Augmedics	DOCUMENT CODE: DOC00009	PAGE: 1 of 2
TITLE: Declaration of Change C2PC		REV. : 1

Declaration of Change

Figure 1

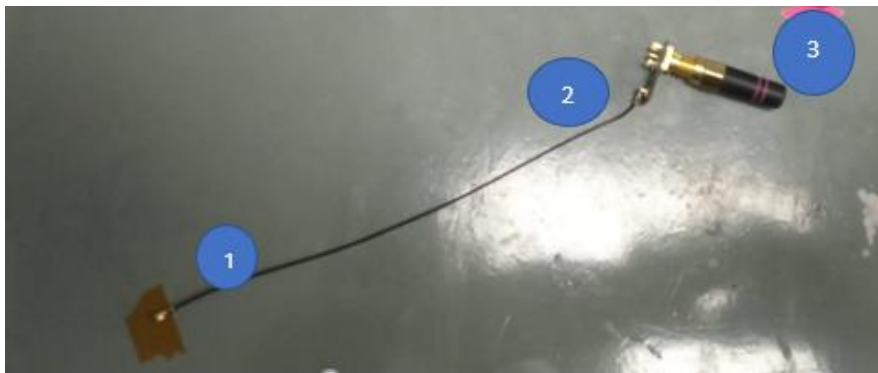
- Additionally, on 7/2020 further C1PC changes were made:
Replacing attenuator MNF PN AT0603T02ECATB (ATC) which was approved in pervious ITL Test Report No. E207760.01 with new attenuator MNF PN PAT1220-C-2DB-T5 (SUSUMO).
As a result from that the PCB PCB00012 modified to PCB00012-2 due to the changes of the footprint AT1(-2db attenuator). For further information see ITL Test Report no. E216220.00. See Figure 1

- Currently, the following C2PC changes have been made:
Removing the PCB00012-2. As a result of that no -2dB Attenuator MNF PN PAT1220-C-2DB-T5 and replacing the cable form 415-0085-150 TO Hirose U. FL to SMA PN CB.720 (See Figure 2).

Previous configuration - According to ITL Test Report no E216220.00 testing.
